Staff Report to the Board of Architectural Review Design Review for Bellwether Tukwila Confluence Apartments

Prepared August 12, 2019

Hearing Date	August 22, 2019
File Number	L19-0053 Design Review
Associated Permits	E19-0003 SEPA Decision
Applicant	Diana Keys, Johnson Braund, Inc.
Request	Approval of Design Review application for a 6-story, 103-unit affordable housing apartment building by the Board of Architectural Review.
Location	3703 S. 152 nd Street, Tukwila WA 98188 Parcel #s 0043000116, 0043000108, 0043000112
Comprehensive Plan And Zoning Designation	High Density Residential (HDR)
Environmental Review	Determination of Non-Significance
Public Notice	Notice of Application was posted on site and mailed to surrounding property owners, tenants, and agencies with jurisdiction on June 12, 2019. Notice of BAR public hearing was mailed to property owners and tenants within 500 feet of the property and agencies with jurisdiction on August 5, 2019; published in the Seattle Times on August 8, 2019; and posted on site on August 12, 2019.

Driveway at SE Property Corner

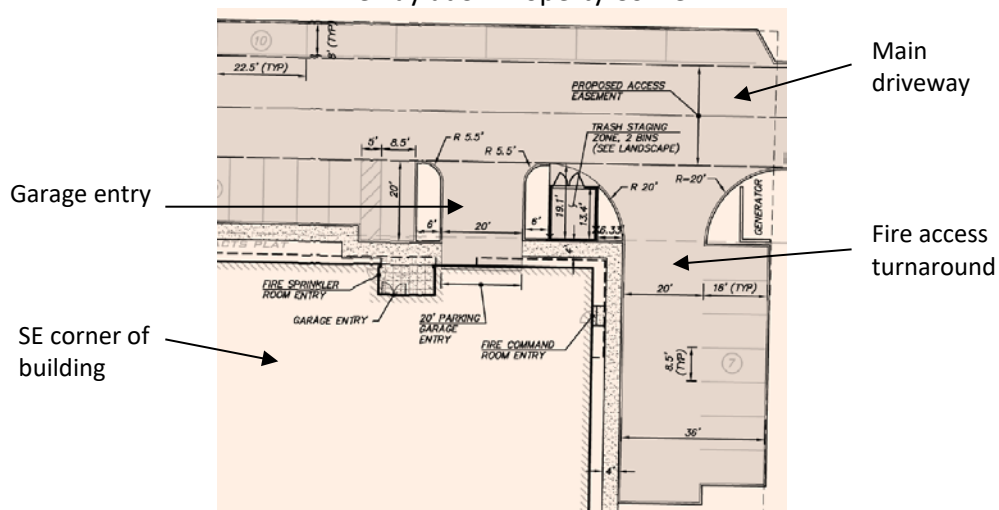
Vehicular access to the site is limited to one driveway off S. 152nd St. The 2-way driveway serves 30 surface parking stalls; parallel parking on the east side of the main driveway and perpendicular parking to the west. The main driveway connects to the parking garage at the southeast corner of the building. Per discussion with the applicant, there will be a marked crosswalk added at the garage driveway crossing to increase pedestrian safety. This will need to be added to the building plan set submittal.

South of the building the driveway bends to the west, functioning as a hammerhead turnaround for fire vehicles and serving 7 perpendicular parking spots. There is a reciprocal fire access easement shared with the multifamily property to the south.

1. The following shall be shown on revised plans submitted and reviewed administratively as part of the building permit application submittal:
 - a. Add a marked crosswalk at the garage driveway crossing for pedestrian safety on the site plan.
 - b. Add a detail illustrating tree protection measures around the Critical Root Zone and indicate location on landscape and construction plans.
 - c. Add a structural soils detail to the landscape plan set. Per 18.52.070.B., for landscaping in sidewalks and parking lots, or in limited areas of soil volume, structural soils (Cornell University product or similar) must be used to a preferred depth of 36 inches to promote tree root growth and provide structural support to the paved area. Minimum soil volumes for tree roots shall be 750 cubic feet per tree.
